KMR.CDD.MmQ.1938.06

**MUNICIPAL CORPORATION  
KARACHI.**

Reference No. B. S. P. 340/38

MODIFIED PLAN OF PROPOSED BUILDING  
ON PLOT NO 28+30, SHEET NO M.M.3,  
MUCCHHI MIANI QR.  
SCALE 8 FT. TO 1 IN.

PLAN OF PROPOSED BUILDING ON PLOT NO 28+30  
SHEET NO MM.3. MUCHHI MIANI QF  
SCALE 8 FT. TO AN INCH

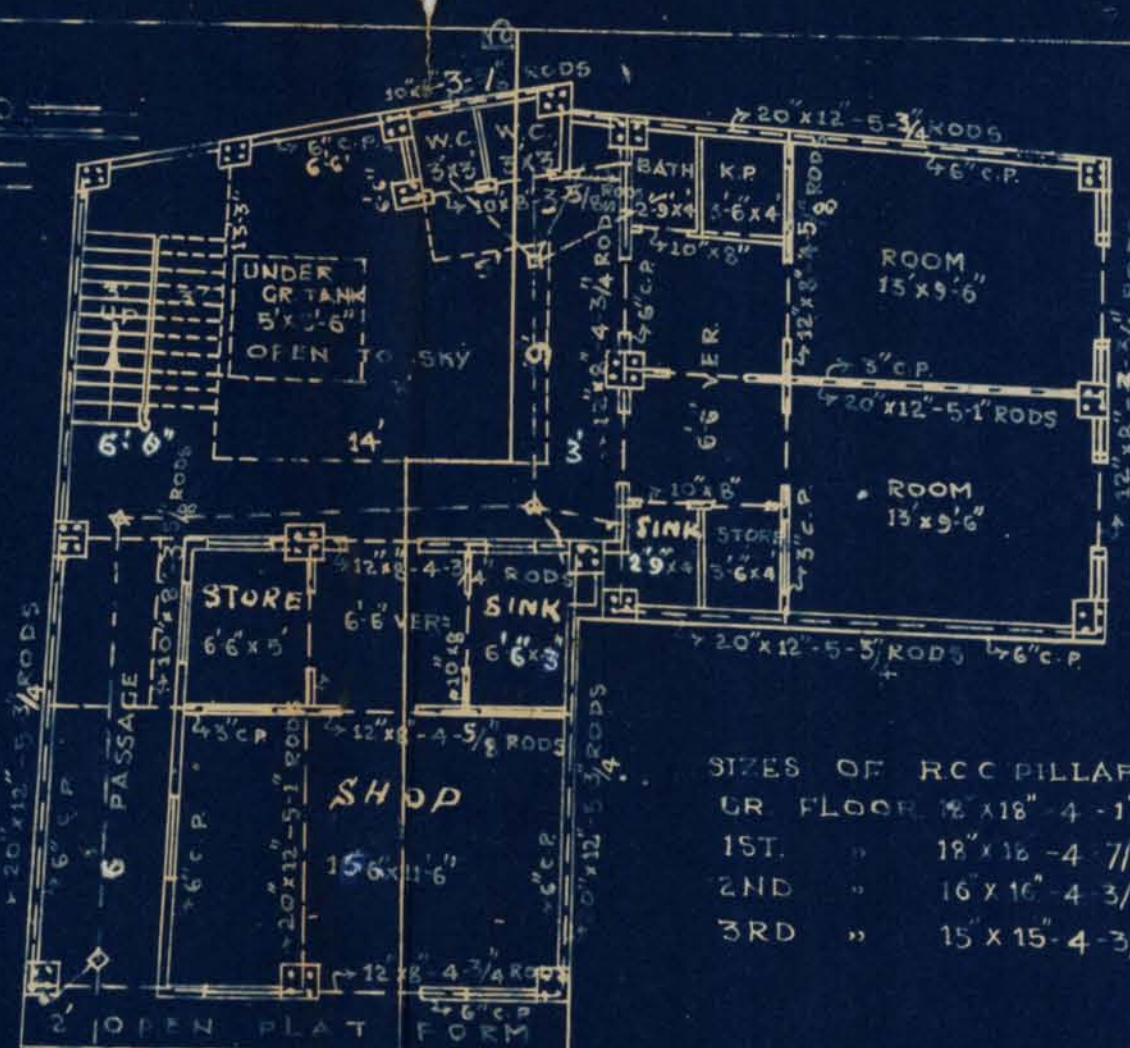
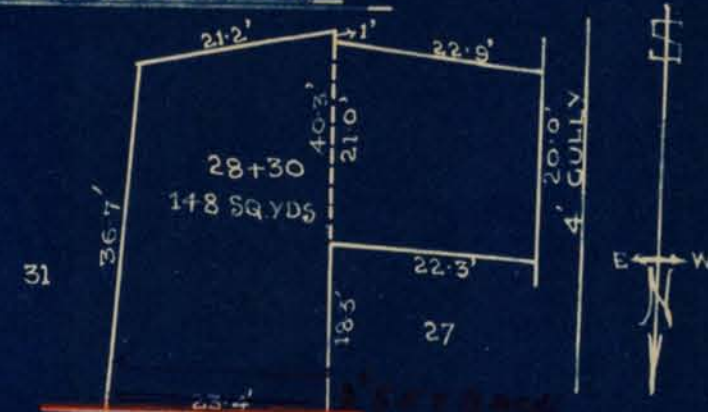
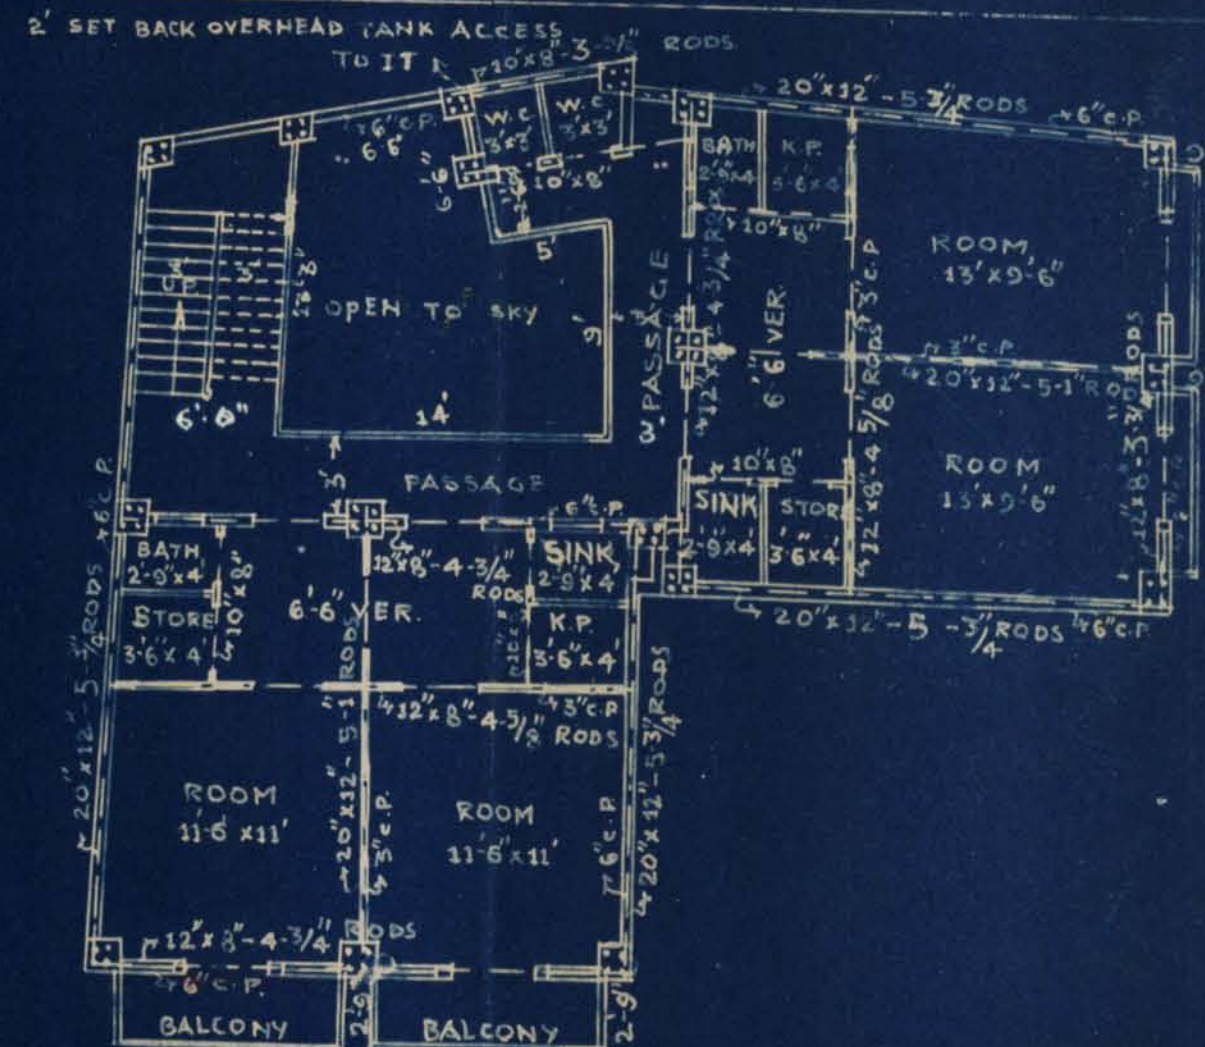
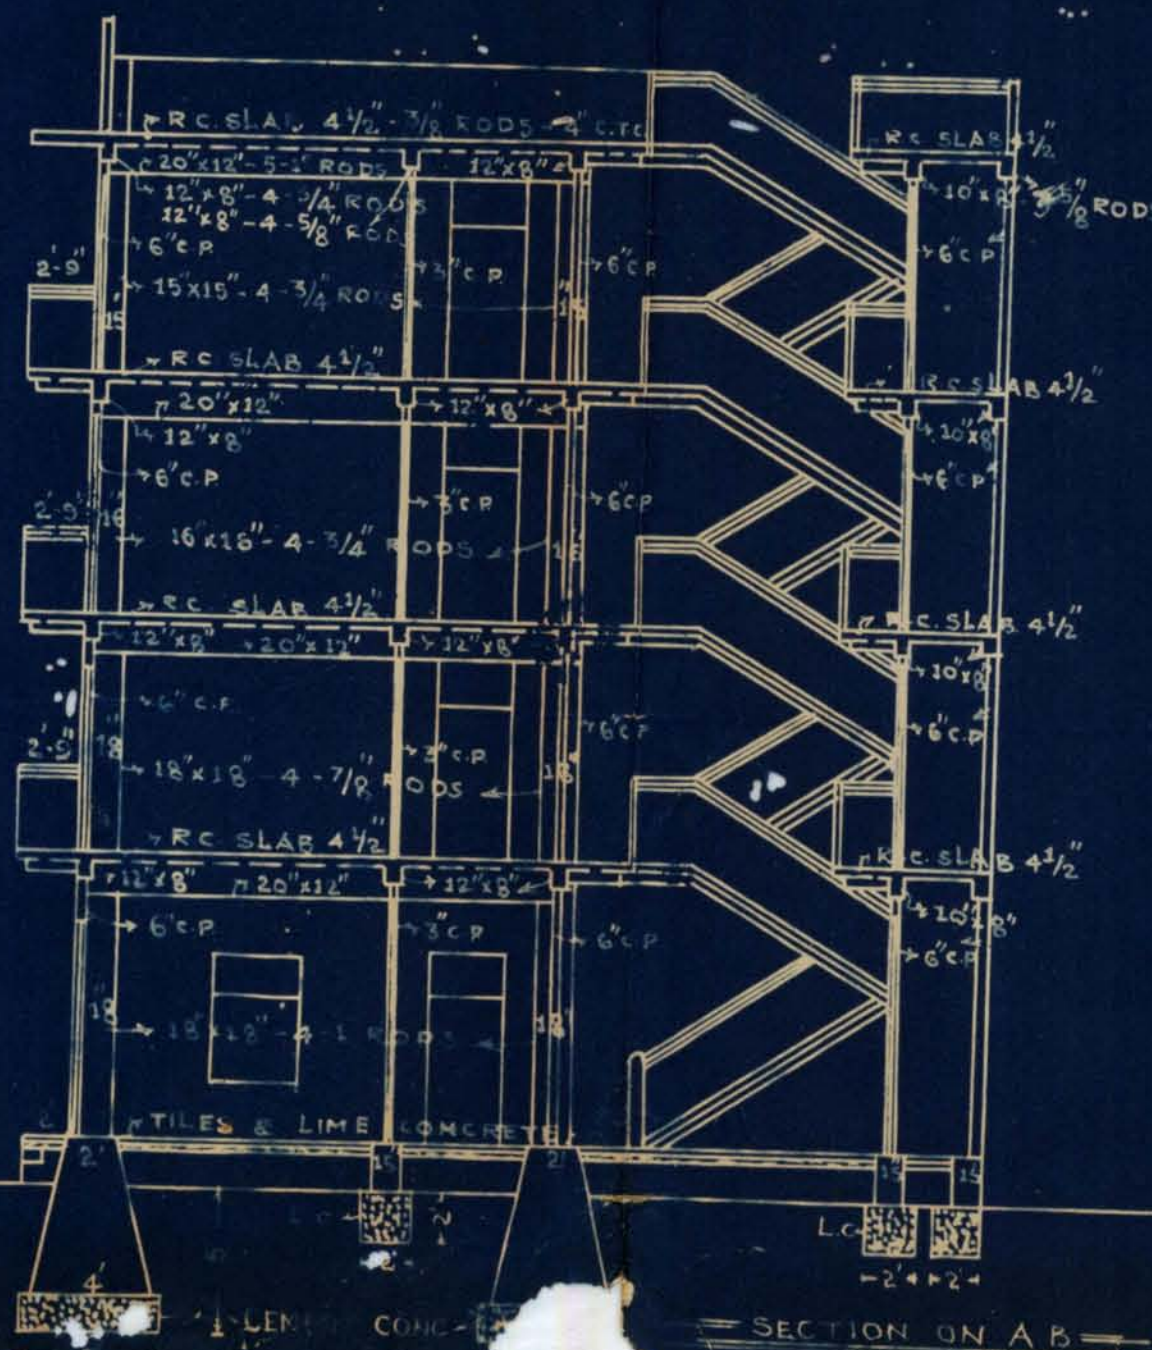
1. Height of the Building must not exceed more than allowable under the Rules.
2. In this locality, no room (elements) cannot be allowed as per order of the CO in that respect.
3. The internal open space for the height proposed must be at least 14' x wide.
4. Load intensity on soil be given with calculations and it must not exceed the allowable.
5. Steps be shown in section as shown in Elevation.
6. Calculations for the R.C. Beam carrying maximum load be given.

- (1) Width of the street, measurements & southern boundary of the plot to be corrected.
- (2) Plots to be amalgamated

u.g. Tank is too close to the  
Drainage lines  
O.H. Tank should be 2 ft away  
from the adjoining owner's wall.

Rooms abutting on a public  
alley are objected.

I am submitting 4 fresh corrected  
Plans, in which the objections of Land  
Survey, Sub. Engrs & Building Survey  
are removed. I have made  
an open space of 14' wide as  
according to rules -
